**SOUTHWEST LANDFILL
RANDALL COUNTY, TEXAS
TCEQ PERMIT NO. MSW-1663C**

**SECTION 305.62(j)(2)
LIMITED SCOPE MAJOR PERMIT AMENDMENT**

**ALTERNATIVE LINER DESIGN
SECTORS 17D THROUGH 29**

Re: Response to Notice of Deficiency Letter – Limited Scope Major Permit
Amendment Application
Southwest Landfill
Randall County, Texas
MSW Permit No.: 1663C
Tracking No. 29885599

SHEET IIIA-A.6A

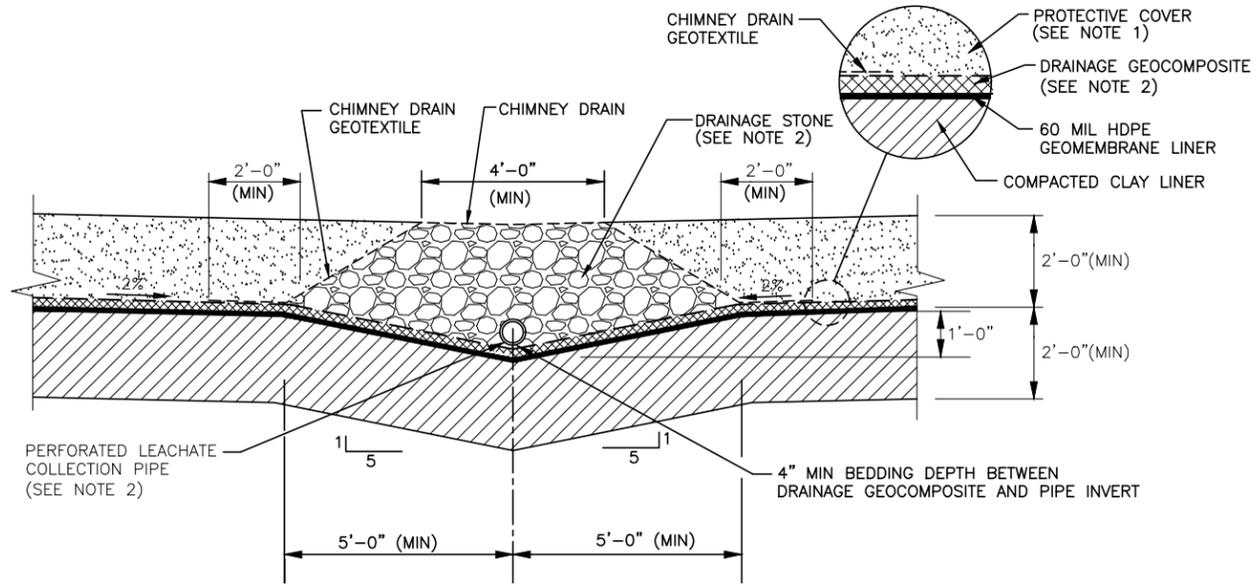
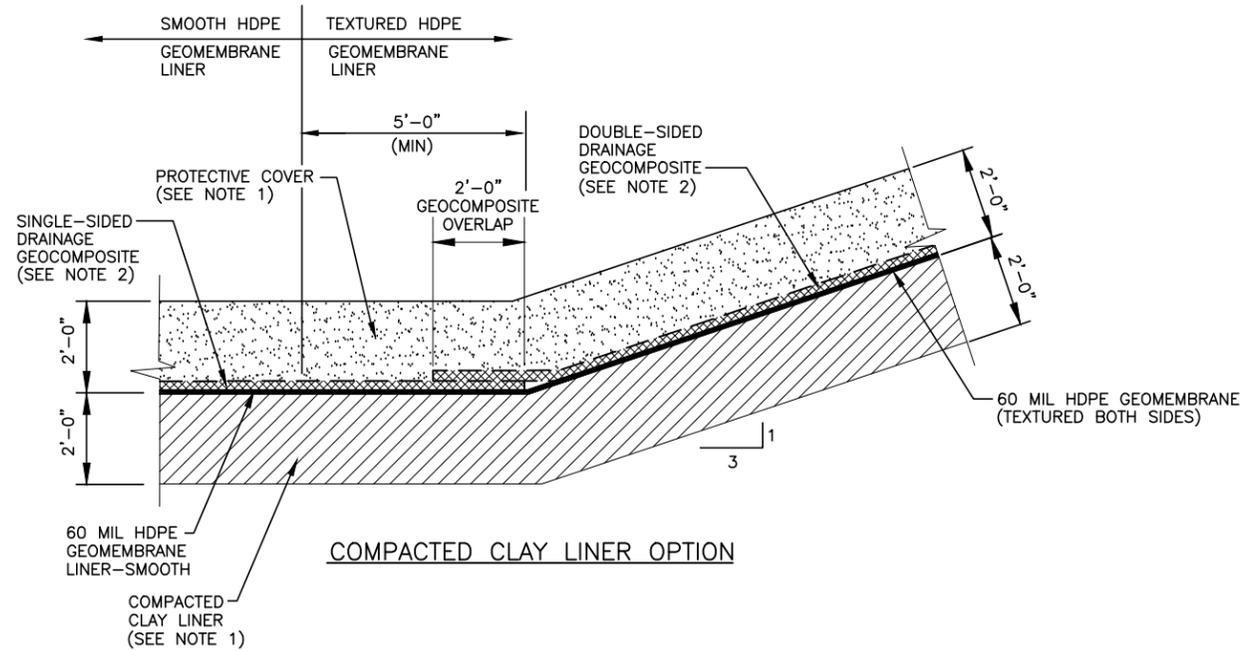
- 6. Part III, Appendix IIID, Liner Quality Control Plan. Section 2.2. Clarify that any geosynthetic clay liner for the alternate liner design in Sectors 17D through 29 would replace a compacted clay liner and not a geomembrane.**

Appendix IIID section 2.2 was revised to clarify a GCL can only replace the 2-foot-thick compacted clay liner portion of the liner.

SHEET IIIB-D-6

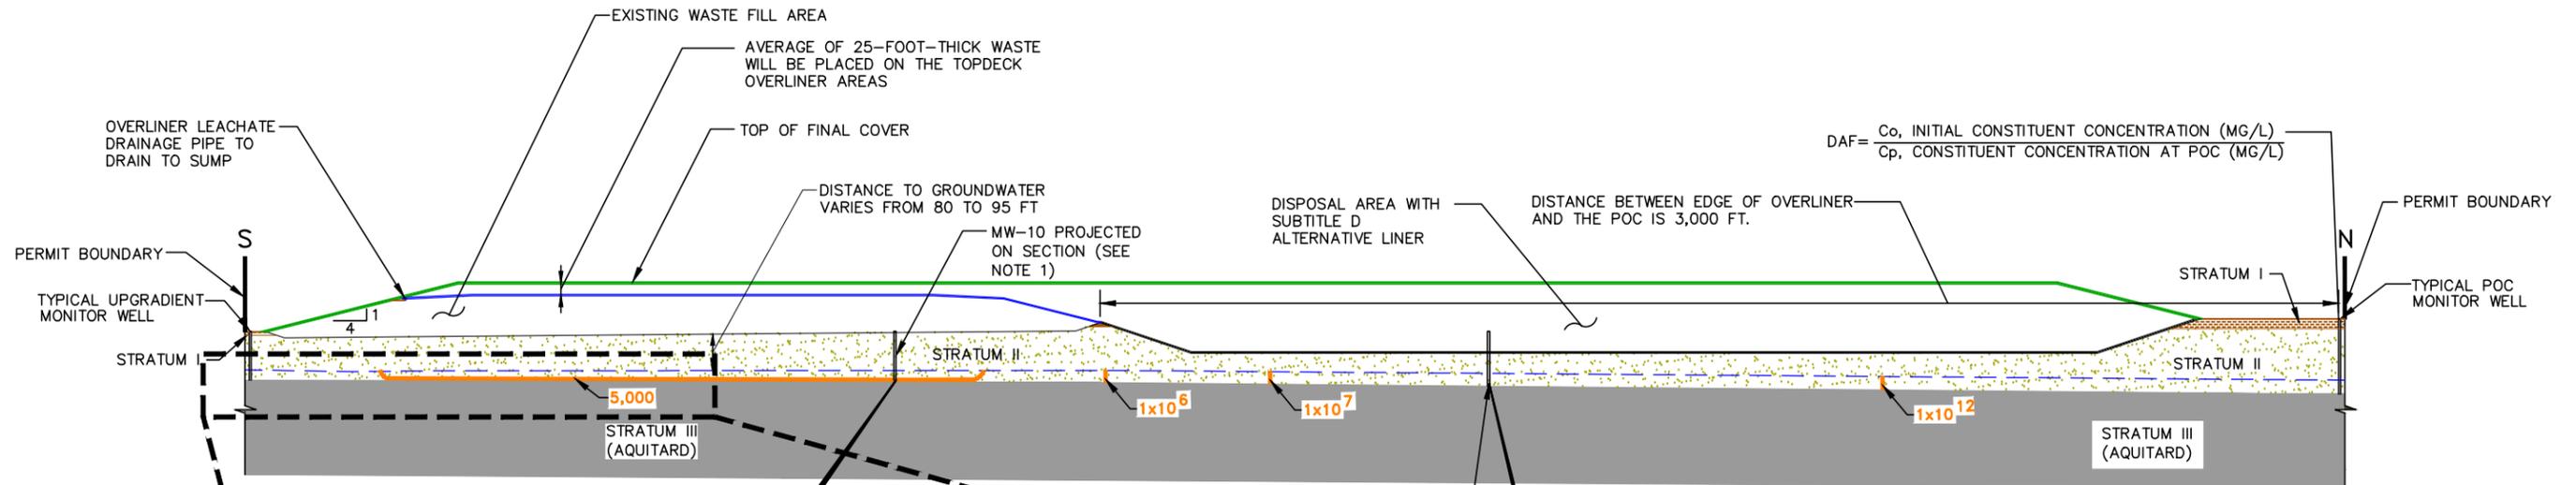
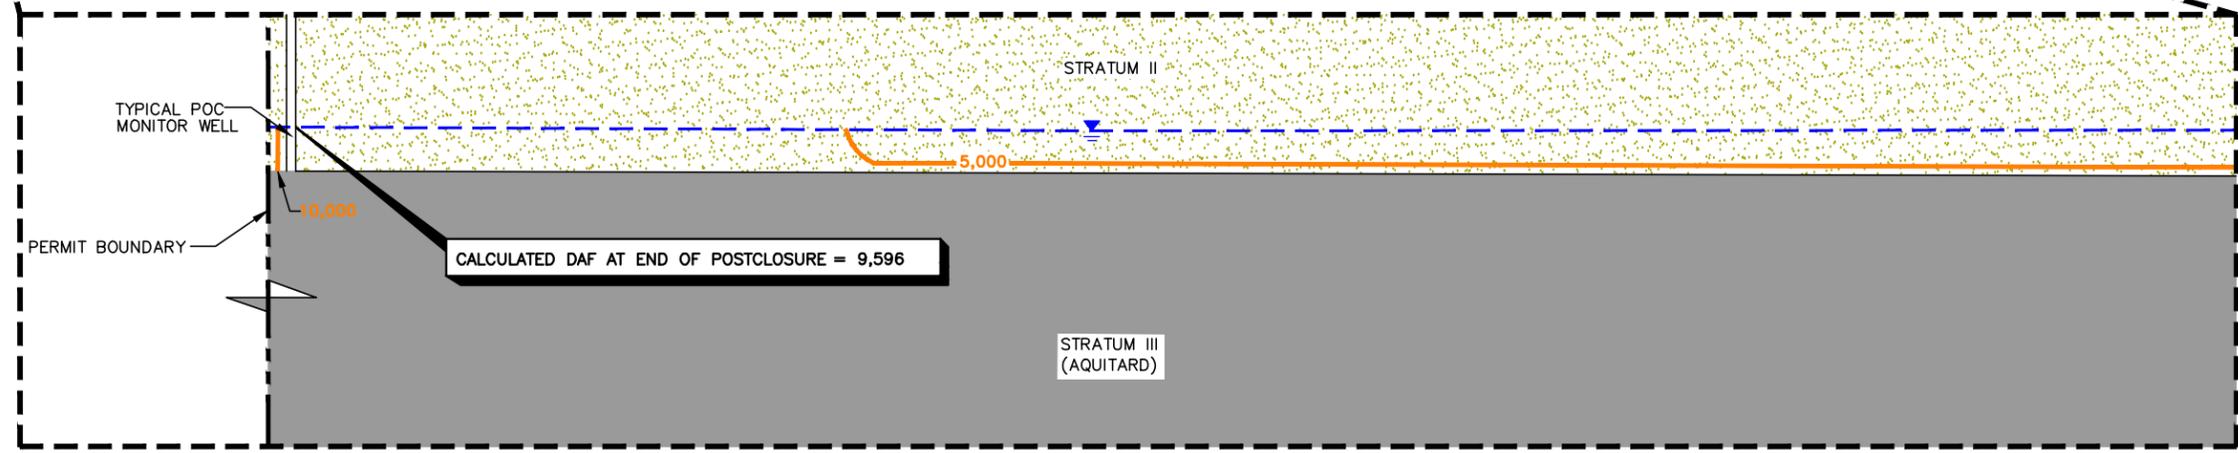
- 4. Part III, Appendix IIIB, Section 6.4, Table 6.2. Ensure the dilution attenuation factor for Case III matches the dilution attenuation factor shown on Appendix IIIB-D, Figure 5.**

Table 6.2 in Appendix IIIB, Section 6.4 was revised to reflect the correct DAF value for Case III, which is correctly shown in Figure 5 in Appendix IIIB-D.
